ORDINANCE NO. 3932

AN ORDINANCE OF THE CITY COUNCIL OF THE CITY OF CHANDLER, ARIZONA, AMENDING SECTION 43-5.1 OF CHAPTER 43 OF CHANDLER CITY CODE; RELATING TO THE CITY OF CHANDLER STANDARD DETAILS AND SPECIFICATIONS.

SUBJECT: May 2008 Amendment to the Engineering Standard Details and Specifications (2007 Edition)

DETAIL NO. C-210 NTS	 CITY OF CHANDLER STANDARD DETAIL	RESIDENTIAL COLLECTOR STREET TYPICAL CROSS SECTION	APPROVED: _____ CITY ENGINEER DATE: _____	DETAIL NO. C-210 NTS
-----------------------------------	---	--	---	-----------------------------------

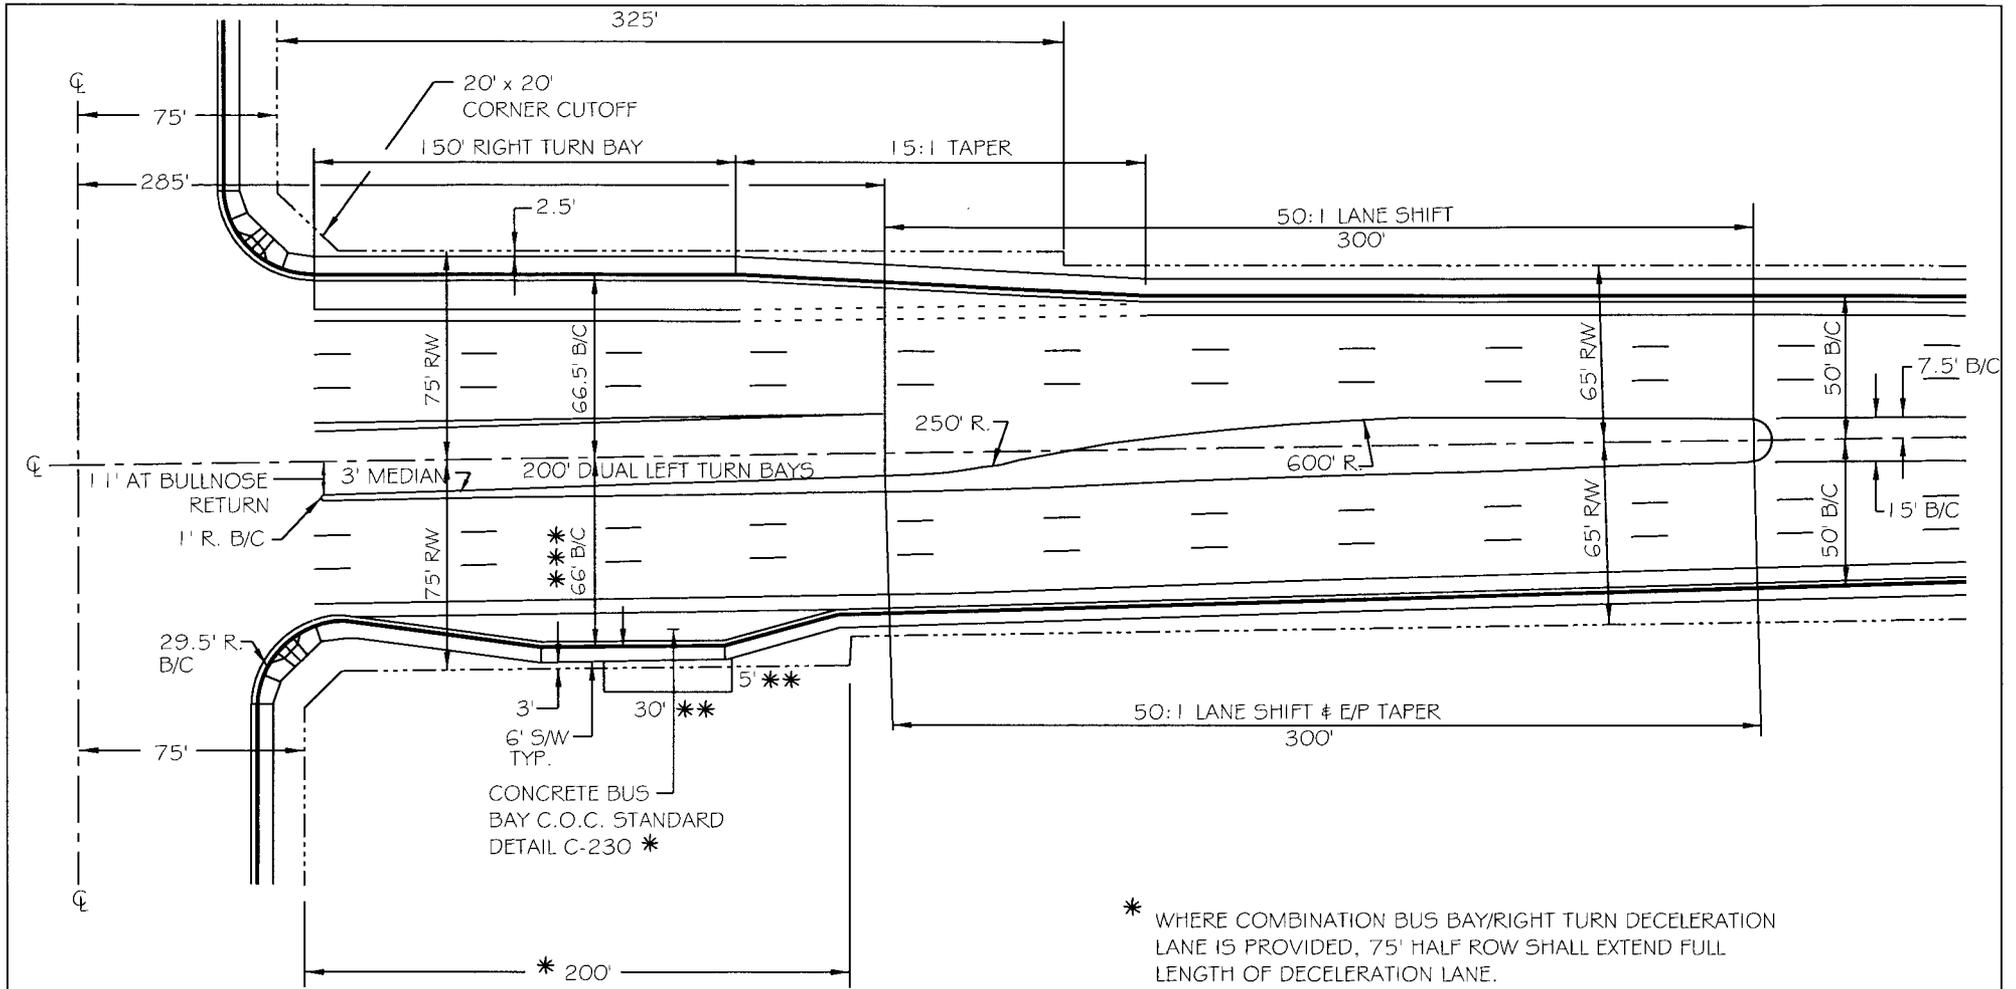
- Detail C-210 - revised cross section dimension from 21' B/C to 22.5' B/C.
- Detail C-223 (Pg 2) - revised median bullnose radius dimension from 2' B/C to 1' B/C.

DETAIL NO.
C-226
 NTS

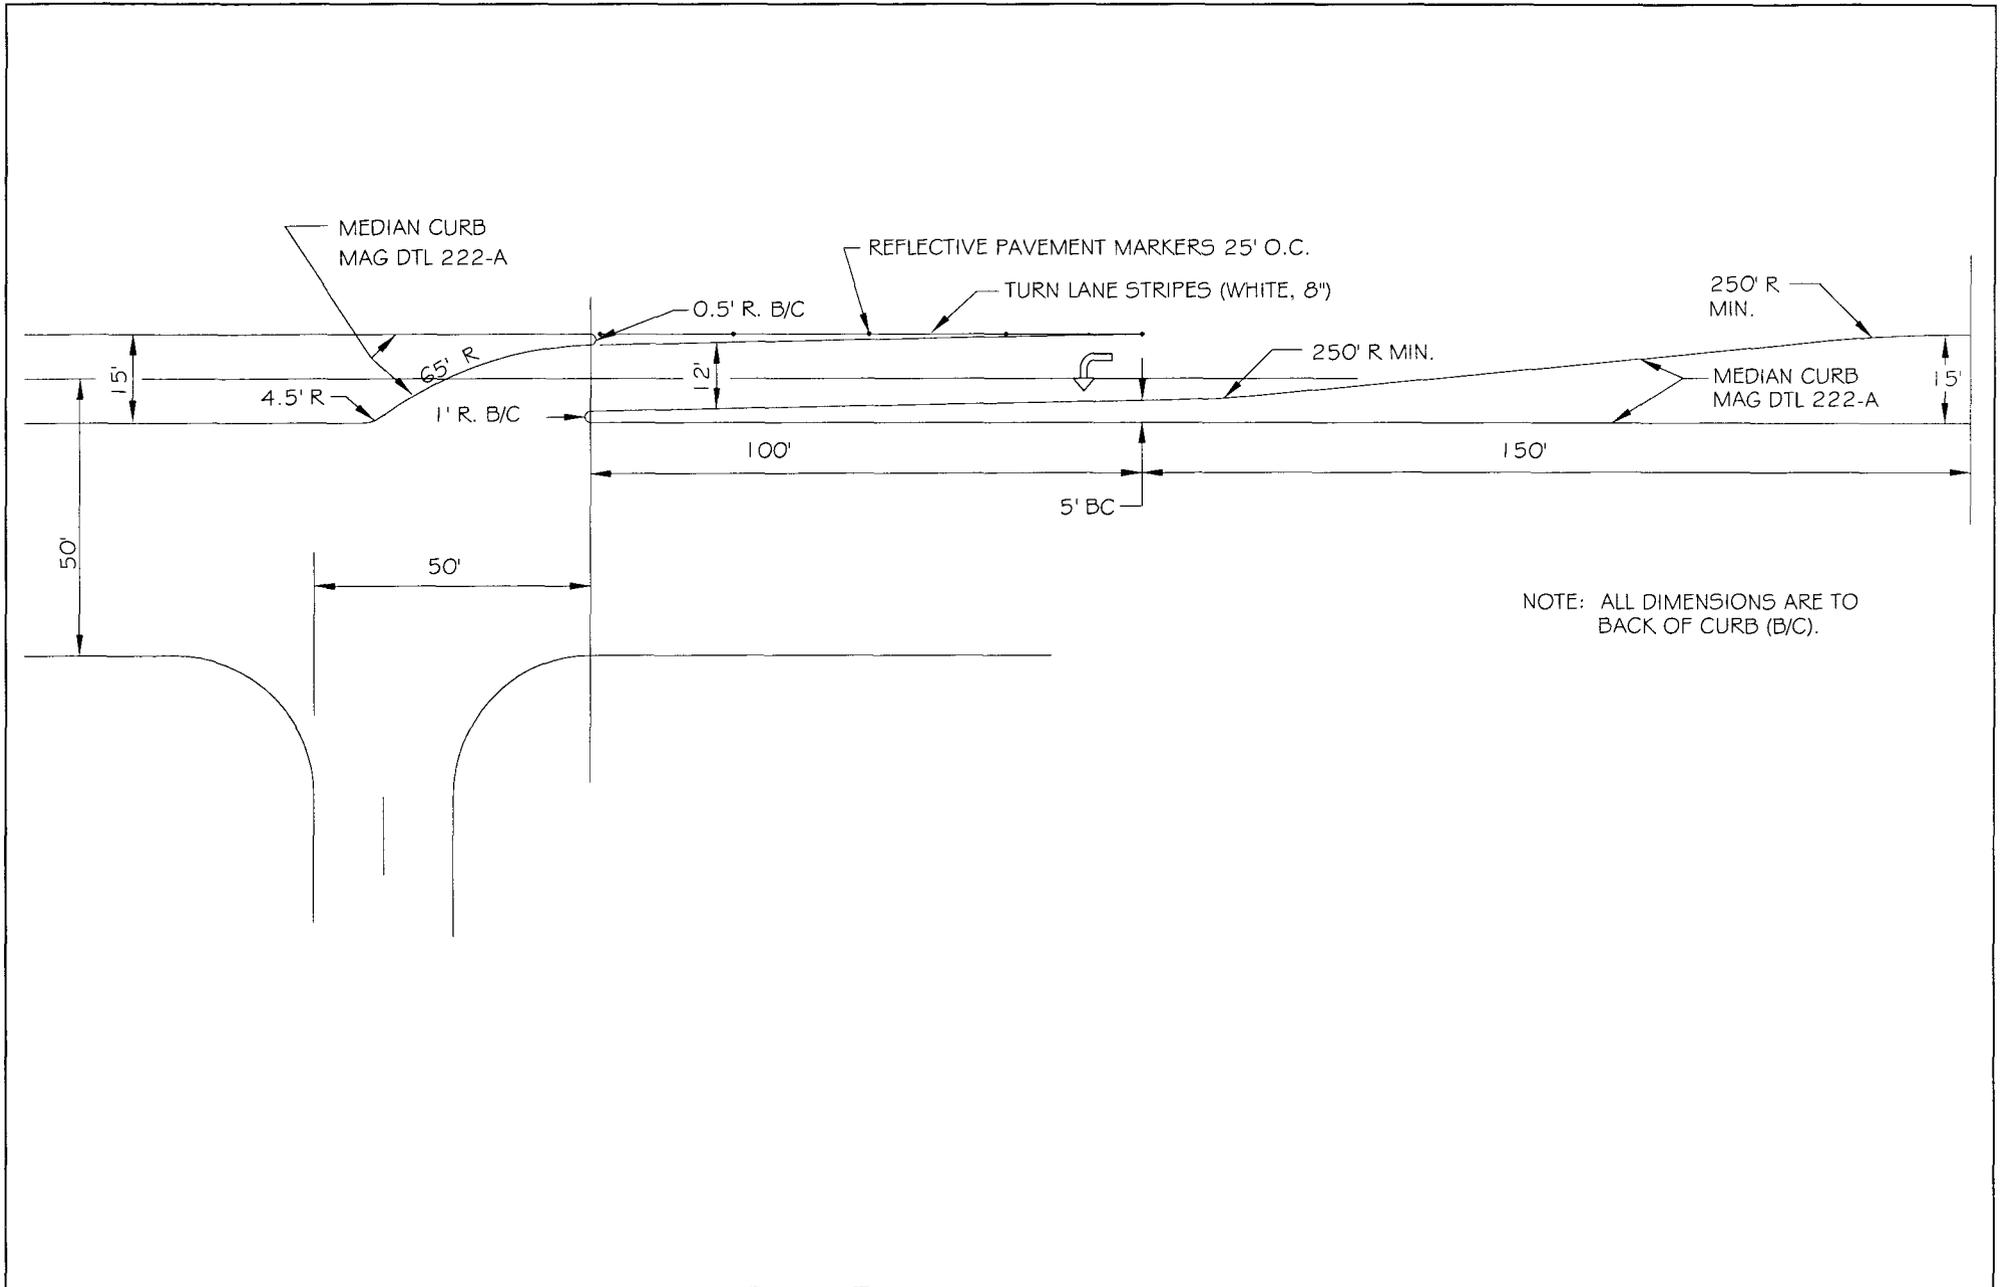
- Detail C-226 - revised median bullnose radius dimension of 1' B/C to 0.5' B/C.
- Detail C-301- graphical revisions for clarification, corrections to notes, updates for a new a polymer meter box and cover and new signal antenna used by Utility Services to read meter usage.

DETAIL NO. C-316 NTS	 CITY OF CHANDLER STANDARD DETAIL	3" TO 10" METER VAULT	APPROVED: _____ CITY ENGINEER DATE: _____	DETAIL NO. C-316 NTS
-----------------------------------	--	------------------------------	---	-----------------------------------

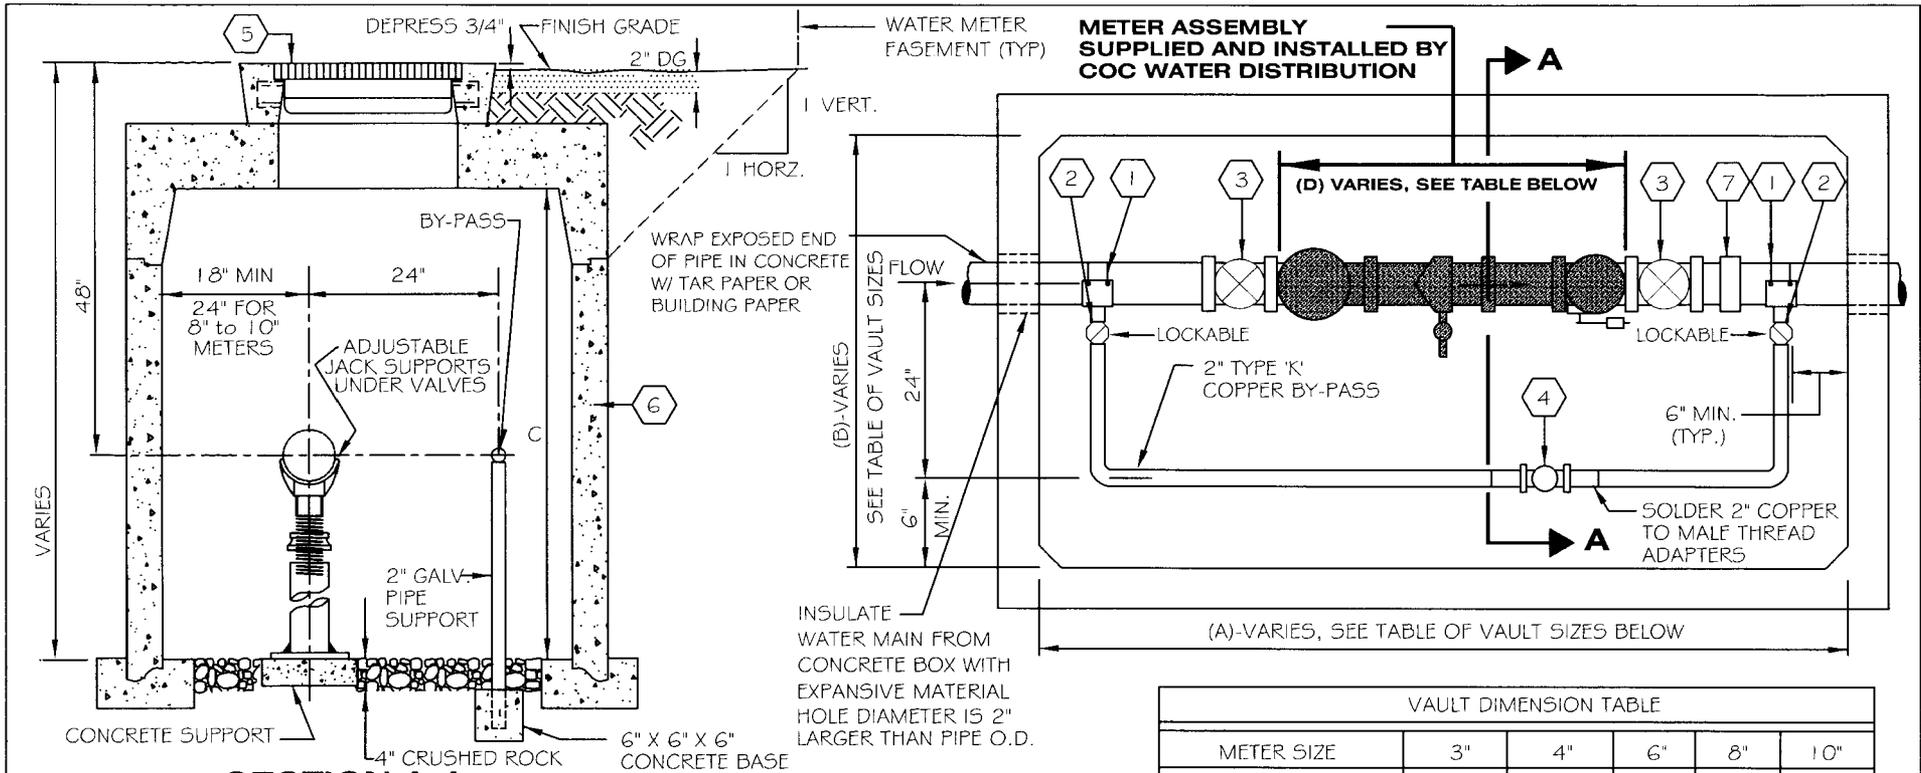
- Detail C-316 - graphical revisions for clarification, corrections to notes, updates for new vault requirements and notes to allow Water Distribution to supply and install all large meters (3" and larger). Note: The city already installs 2" and smaller meters.
